NORTHSTAR ORBITAL LABS / COMPONENT ASSURANCE

# Radiation Test Evidence Candidate Review Package

DOCUMENT STR-24-081 / REV A

Figure 1. Layout-realistic training graphic. Values are deliberately non-authoritative and are excluded from SPECTRA decision input.

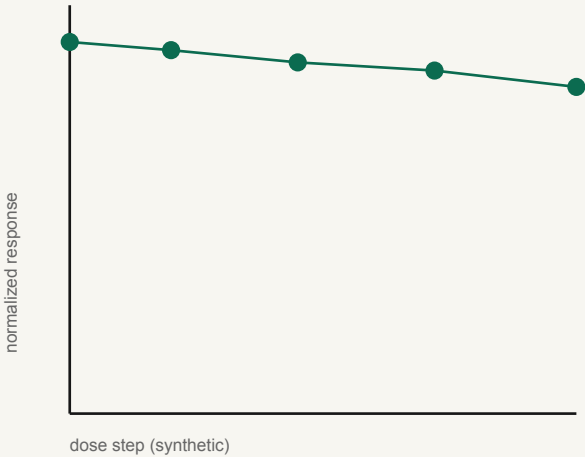
The source memo describes room-temperature irradiation of biased devices. Dose points were recorded by the test operator, but the facility certificate and dosimetry chain are not included in this package.

A functional check was reportedly performed after each exposure. The narrative mentions SEU behavior only as a follow-up topic; no event cross-section table or beam species record is attached.

"Electrical parameters remained within the synthetic acceptance band. This sentence is training content and must not be interpreted as a published result."
